CITY OF CONWAY, ARKANSAS PLANNING COMMISSION

January 18, 2022

Request for Preliminary Plat Approval - Bell Valley Subdivision Phase 4

Request for Preliminary Plat Approval - Orchard Hill Subdivision Phase 3

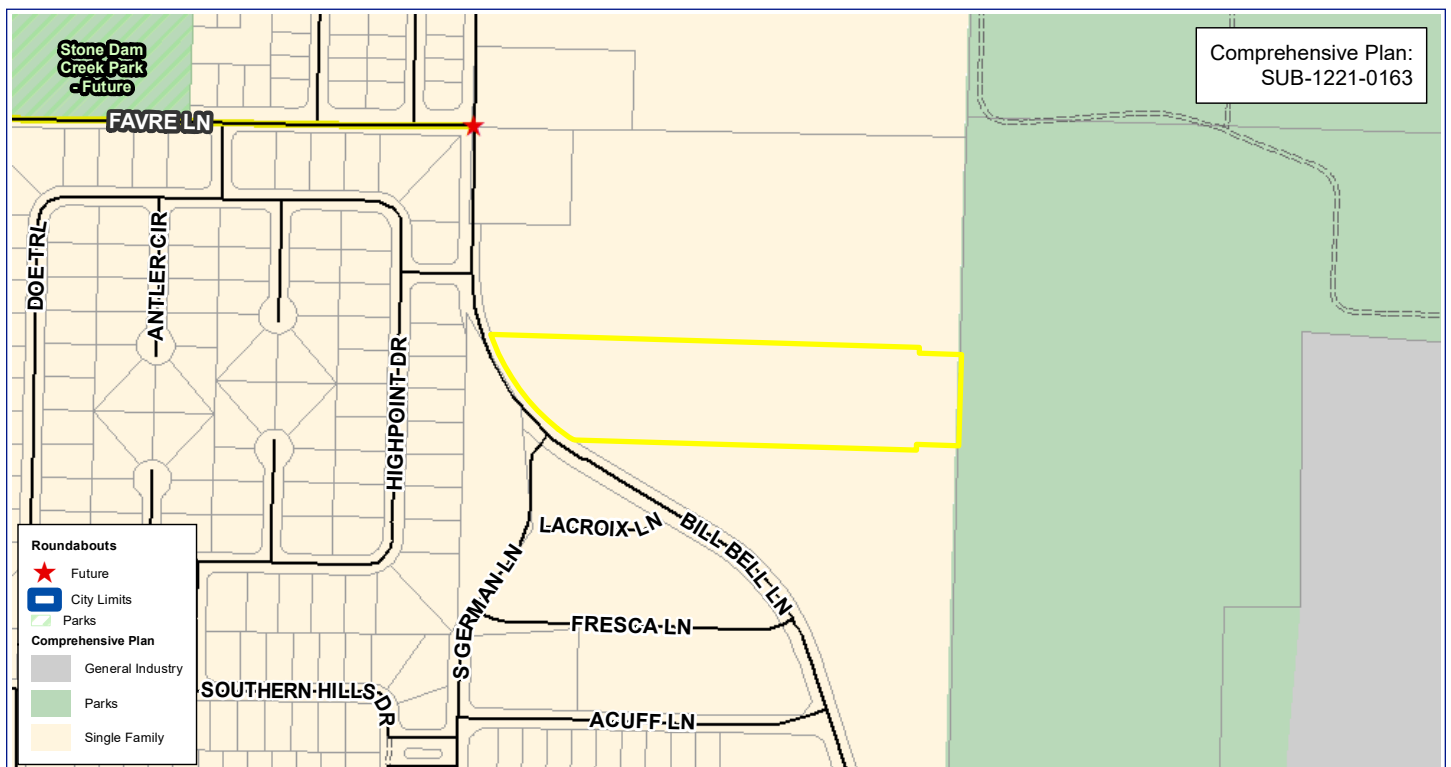
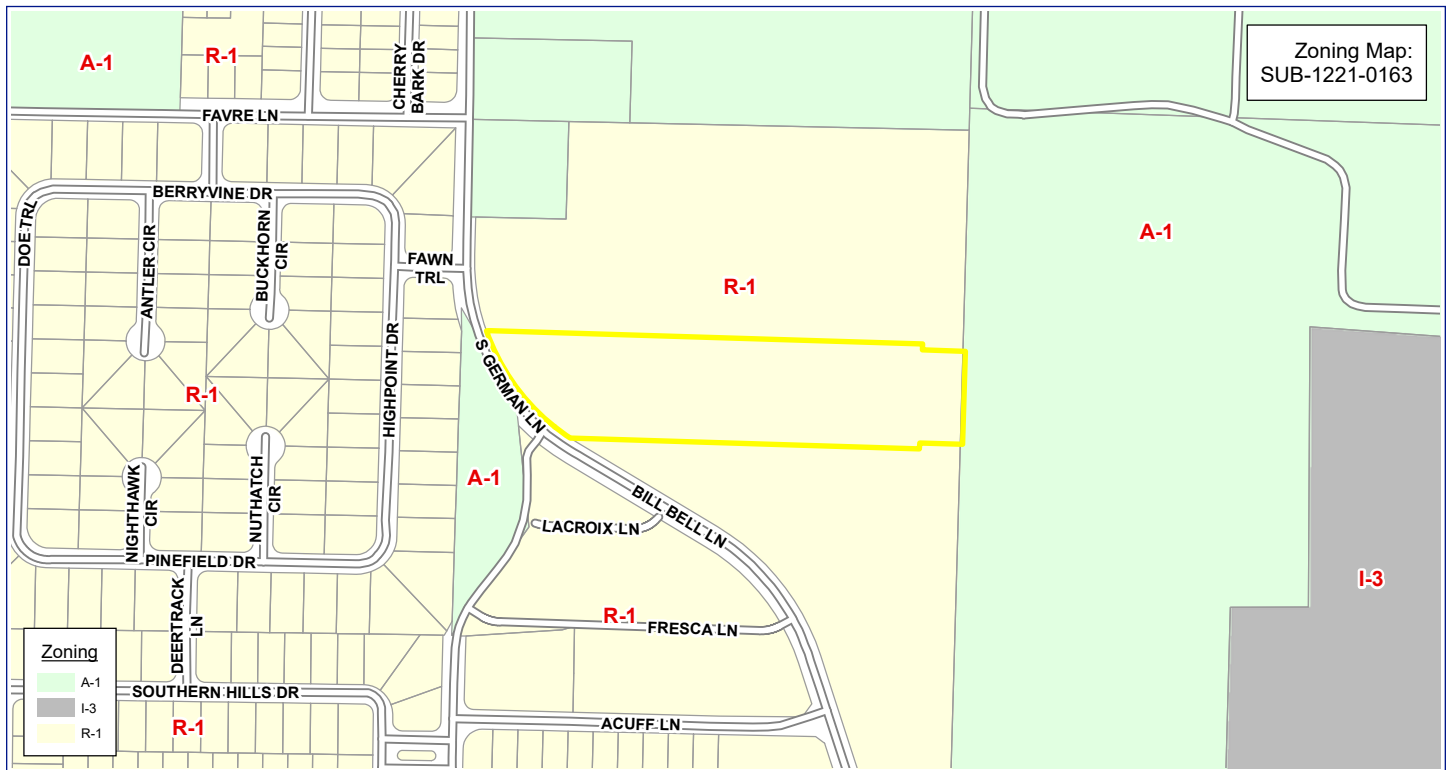
- The subdivision is designed so that no lots in this phase directly access Bill Bell Ln or South German Ln; a 10-foot planting easement is included along the frontages for these lots.
- The subdivision will connect to Phase 3, adjacent to the south; a stub out is provided for future connection to the north.

CORRECTIONS NEEDED ON THE PLAT

1. Show location of all fire hydrants.
2. Street names shall be proposed and availability confirmed with GIS Manager.
3. Drainage easement [shared by Lots 32 and 33] alignment revised to center on property line and/or easement increased to accomplish centering on property line.
4. Corrections as noted on the Preliminary Plat and Street & Drainage Plans as provided to the applicant.

5. Wheelchair ramps shall be installed by the developer/subdivider in accordance with the City of Conway Transportation Department Standard Details.
6. Sidewalks along the South German Ln and/or Bill Bell Ln frontages of Lot 53 and Lot 22 shall be constructed by the developer/subdivider, as the street is of a Collector classification, in accordance with the City of Conway Transportation Department Standard Details.

7. Lots 53 and 22 shall not take access from South German Ln/Bill Bell Ln.
8. The Street and Drainage Plans/Drainage Report shall be modified to meet the requirements necessary for approval by the City Engineer.

10. Fire hydrants must be placed so that the furthest point of a lot in a residential subdivision is not more than 600 feet from the hydrant located on the same street. Variances must be approved by the Planning Commission and Fire Chief.

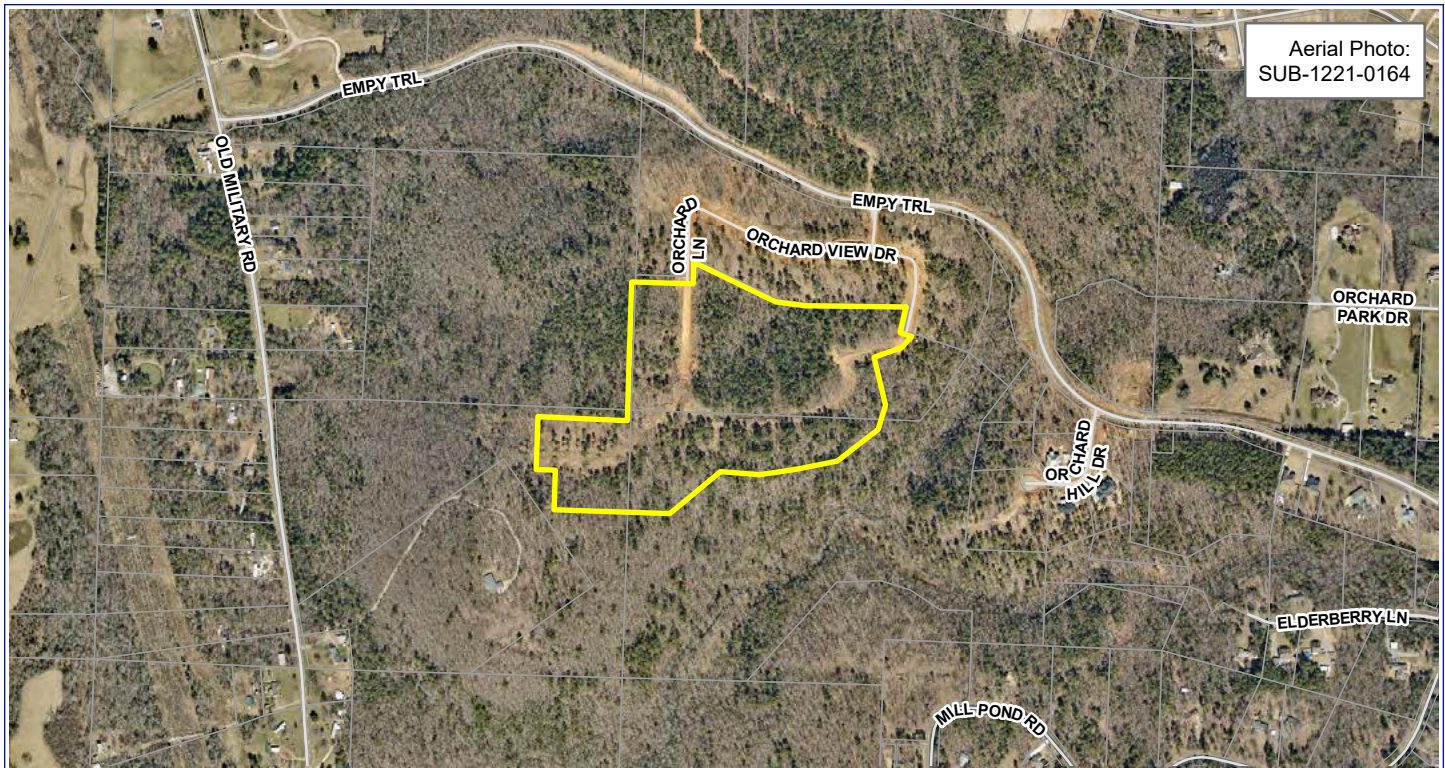
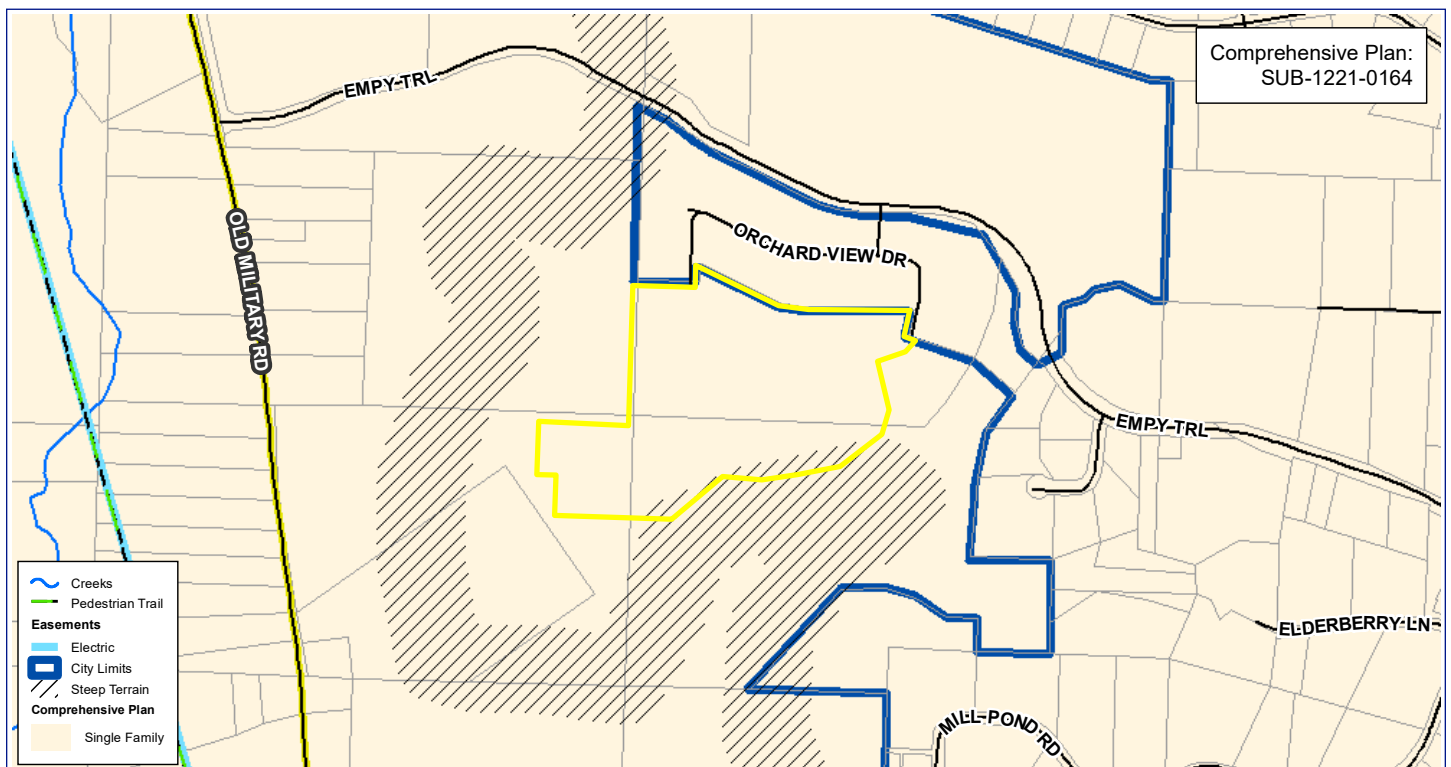
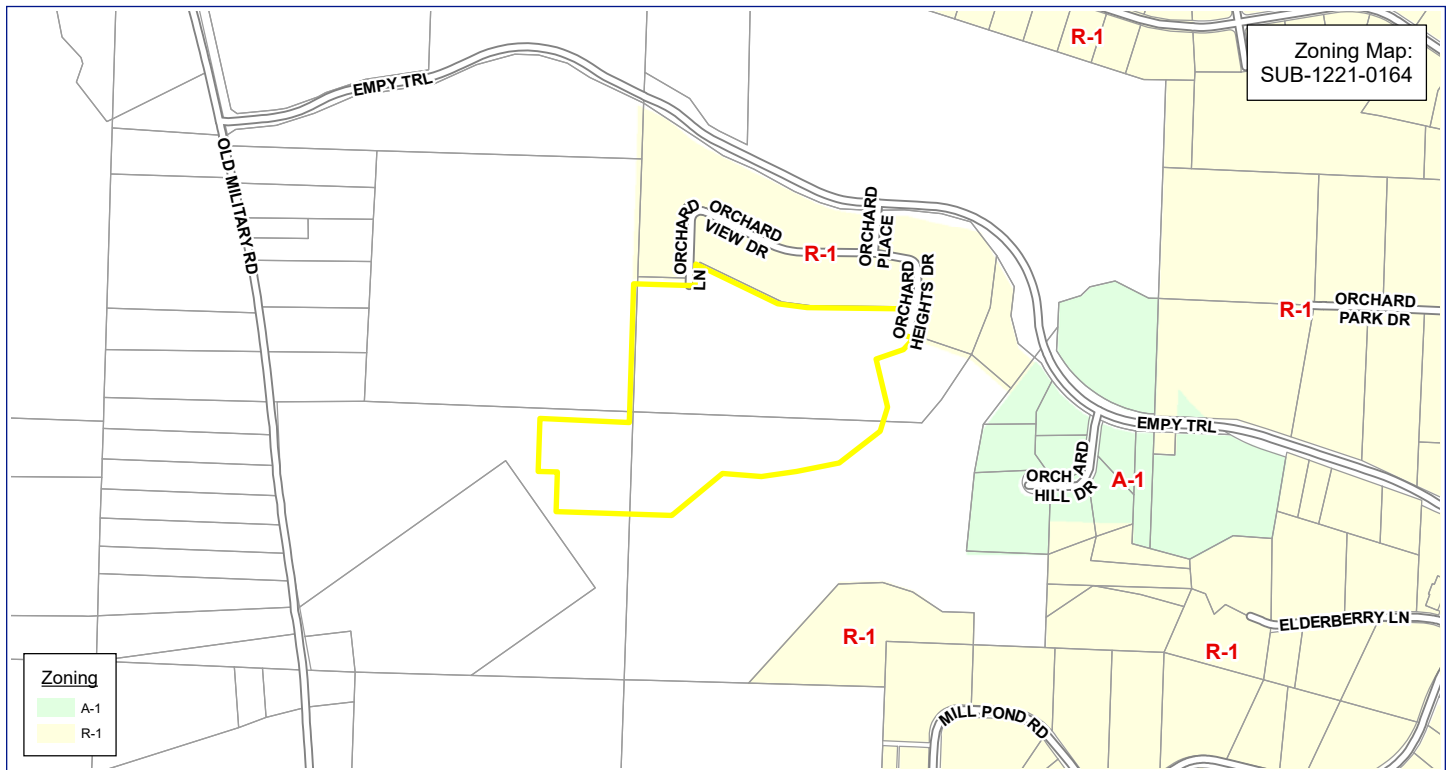
- The subdivision will connect to Phase 2, adjacent to the north. Two stub outs are provided for potential future connection to the west and south.
- Construction of a temporary fire apparatus turnaround is required at the stub street along the western boundary, until future street connection is established. If improvement is proposed on adjacent property, it must be placed in a recorded easement and referenced on the plat.
- Proposed stub to the south [between Lots 20-21] should be constructed as ROW, not indicated as an access easement, if future connection to the south is anticipated.
- Cul-de-sac design on unnamed street should be revised; lessen depth or consider addition of an island in center.

CORRECTIONS NEEDED ON THE PLAT

1. Show location of all fire hydrants.
2. Street names shall be proposed and availability confirmed with GIS Manager.
3. Hammerhead fire apparatus turnaround relocated or placed in a recorded easement and referenced on plat.
4. Cul-de-sac design should be revised. Applicant to coordinate with Transportation and Planning Departments to achieve an acceptable design.
5. Corrections as noted on the Preliminary Plat and Street & Drainage Plans as provided to the applicant.

6. If the property is annexed in the future, all construction commencing following annexation will be subject to in-lieu of sidewalk construction fees.

7. The Street and Drainage Plans/Drainage Report shall be modified to meet the requirements necessary for approval by the City Engineer.
8. A draft of a Bill of Assurance for the proposed subdivision describing proposed covenants, restrictions and conditions applicable to the property included in the submitted plat.

9. Fire hydrants must be placed so that the furthest point of a lot in a residential subdivision is not more than 600 feet from the hydrant located on the same street. Variances must be approved by the Planning Commission and Fire Chief.

1 ARCHITECTURAL SITE PLAN
1" = 20'-0"

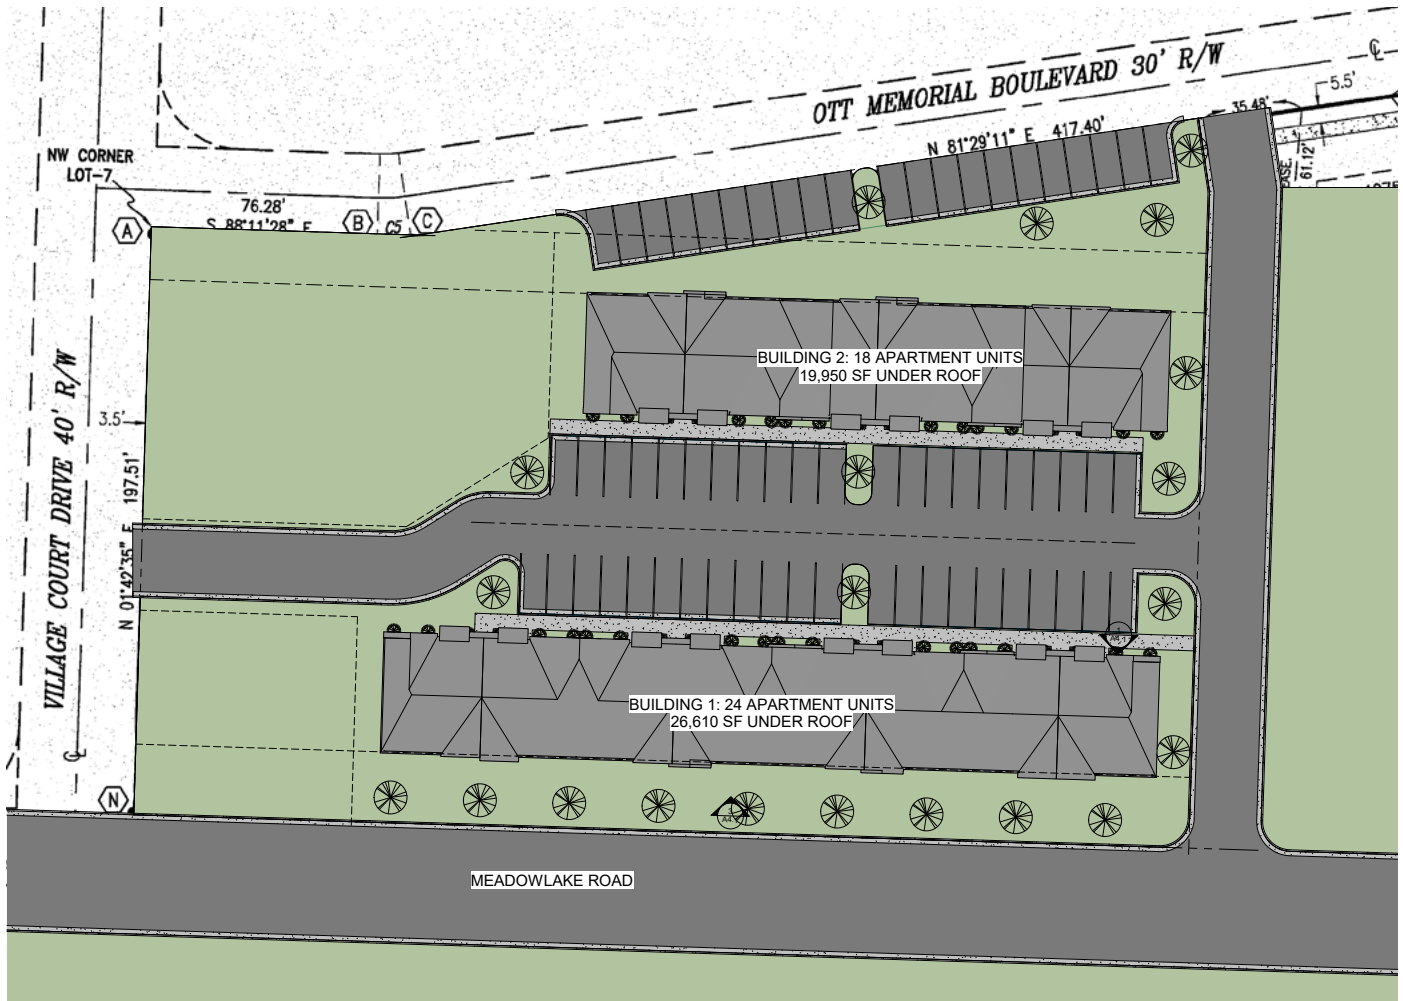
- The Comprehensive Plan designates the area as mixed-use. The amendment allows such development in a consistent manner with the plan.
- The applicant is seeking to modify the PUD to allow more multi-family development on the site. Currently, the PUD allows 80-85% to be occupied by single-family, town home, or apartment uses. The amendment as proposed would allow the entirety of Lot 7 to be devoted to residential use.

Staff recommends approval of the PUD modification as it is consistent with the Comprehensive Plan, would allow for appropriate use of the property in context to the surrounding area, and would not likely negatively impact adjacent properties. However, staff does not fully concur with the applicant's request. Below is staff's recommendation for the modification as well as a list of conditions for approval.

The PUD shall be amended such that the proposed amendments apply only to Lot 7C of the North Market Plaza Replat. All previous resubdivision of Lot 7 shall be governed by the PUD regulations previously established for Lot 7.

Buildings shall be located in a manner generally consistent with the architectural site plan and in accordance with the building lines established for Lot 7C on the North Market Plaza Replat filed in Book L, Page 55 with the Faulkner County Circuit Clerk. Outbuildings must be setback a minimum distance of twenty feet from the principal building. A minimum of ten feet shall separate all detached buildings.

Minimum five feet wide sidewalks shall be constructed along Ott Memorial Boulevard. Sidewalks shall be constructed so as to produce a continuous ribbon of pedestrian access throughout the development.

Minimum five feet wide sidewalks shall be constructed along the west side of the North-South running access on the east side of the property.

The development shall provide vehicular and pedestrian connection to the existing access easement directly east of the property known as Cambridge Village Drive.
